06-84 – 2021

611(New)

Proponent: Amy Carpenter, representing Assisted Toileting and Bathing work group

SECTION 611 **ASSISTED TOILET AND BATHING ROOMS**

FIGURE 611.5
ASSISTED USE WATER CLOSET

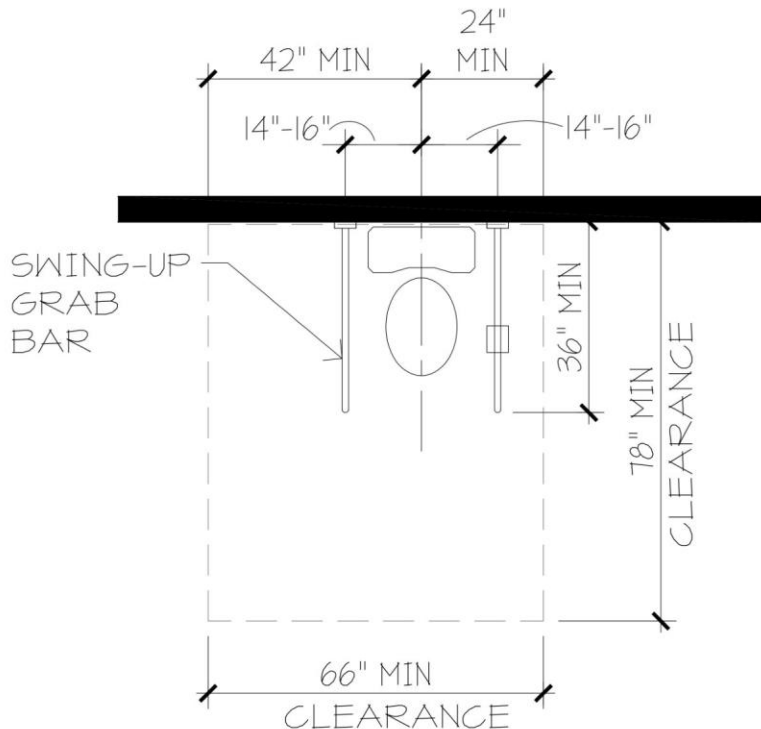
611.5.1 Clearance width. Clearance around the water closet shall be 66 inches (1676 mm) minimum. A minimum dimension of 24 inches (609 mm) shall be provided on each side, measured from the centerline of the water closet.

611.5.2 Clearance depth. Clearance around the water closet shall be 78 inches (1981 mm) minimum in depth, measured perpendicular from the rear wall.

611.5.3 Clearance overlap. The required clearance around the water closet shall be permitted to overlap the water closet, associated grab bars, paper dispensers, sanitary napkin receptacles, coat hooks, shelves, accessible routes, clear floor space at other fixtures and the turning space. Towel bars that meet the strength requirements of Section 609.8 shall be permitted to overlap the clearance at the water closet. No other obstructions shall be within the required water closet clearance.

611.5.5 Grab bars. Grab bars for assisted toileting shall comply with Sections 611.5.5.1 through 611.5.5.6

611.5.5.1 Swing up grab bars shall be provided at both sides of the water closet.

611.5.5.2 Swing up grab bars shall be located 14 to 16 inches (355 to 406 mm) from the centerline of the water closet.

611.5.5.3 Swing up grab bars shall extend a minimum of 36 inches (915 mm), measured perpendicular from the rear wall to the furthest projection of the bar.

611.5.5.4 The height of the Swing up grab bar, when in the down position, shall be 30 inches (760 mm) minimum and 34 inches (865 mm) maximum measured from the floor to the topmost portion of the bar.

FIGURE 611.5.6
ASSISTED USE WATER CLOSET
FLOOR-MOUNTED SUPPORT POSTS

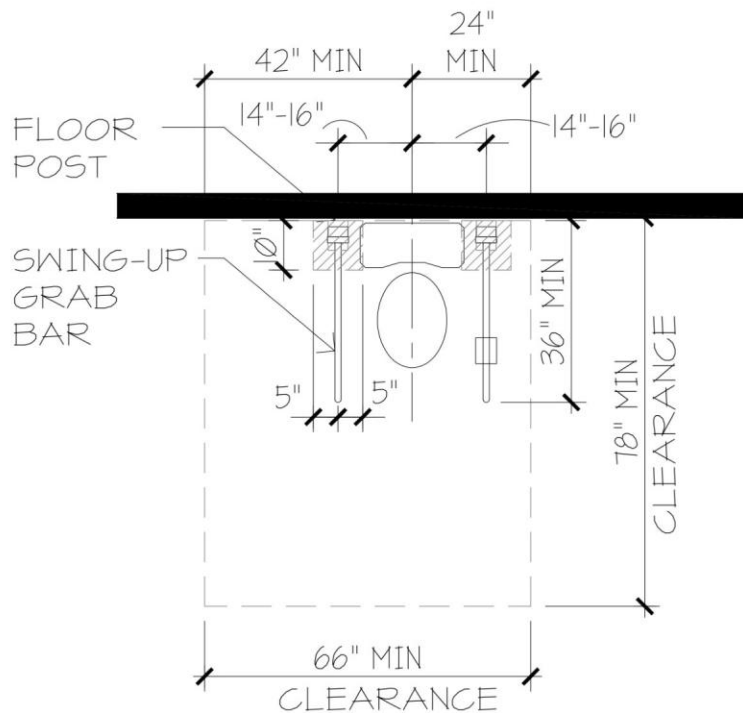
611.5.6 Floor-mounted support post. A floor-mounted support post, used as an alternate means of support for swing up grab bars shall be designed to meet the structural strength requirements of Section 609.8 and shall be permitted to be located within the clearance around the water closet provided it meets all of the following:

1. The floor plate and post shall not extend more than 10 inches (254 mm) in depth measured perpendicular to the back wall,
2. The floor plate and post shall not extend more than 5 inches (127 mm) in width, measured from the centerline of the grab bar to either side,
3. The post location shall not block access to the flush controls, and
4. The floor plate and post shall not overlap any other required clearances or turning space.

The inclusion of a floor mounted support post to attach the swing-up grab bars to was considered to be an important component for both new and existing construction. The Rothschild study calls for the grab bar to extend 6-9" beyond the front edge of the toilet. With most elongated bowl toilets extending approximately 30 inches from the back wall, this requires a minimum length swing-up bar at 36", which is difficult to find on the market today. This also brought up concerns about structural stability of wall blocking and proper connections. One of the task group alerted the group to the support posts that are currently available on the market. Benefits of the support post include the ability to use standard, shorter swing-up bars to still achieve the desired distance in front of the toilet, better structural stability, and the ability of users to better customize the height of the mounting to their specific needs. (people do shrink as they age)

FIGURE 611.7(A)
ROLL-IN SHOWERS FOR ASSISTED BATHING
OPTION 1

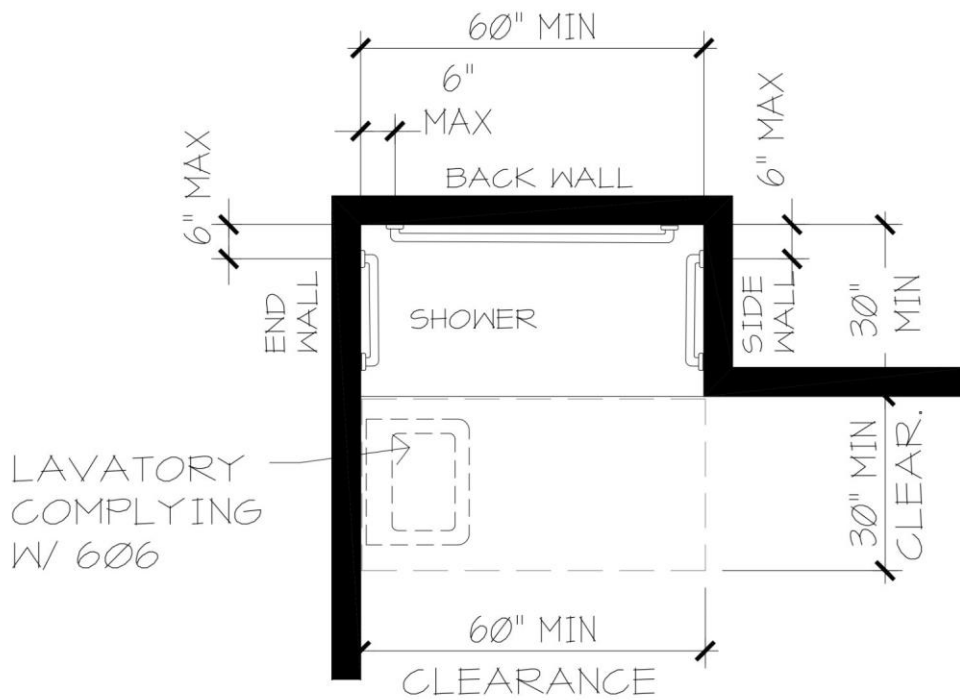
611.7 Showers. Roll-in showers for assisted bathing shall comply with Section 611.7.

611.7.4.1 Horizontal grab bars in roll-in showers for assisted bathing shall be provided on the back wall, end wall and side wall. Grab bars shall extend within 6 inches (150 mm) maximum from adjacent walls.

1. Installed at a height of 38 inches (965 mm) minimum and 48 inches (1220 mm) maximum above the shower floor,
2. Located either on the end wall or side wall, 18 inches (455 mm) minimum and 48 inches (1220 mm) maximum from the back wall, and
3. Located to allow access by a caregiver and minimize reaching through the water stream
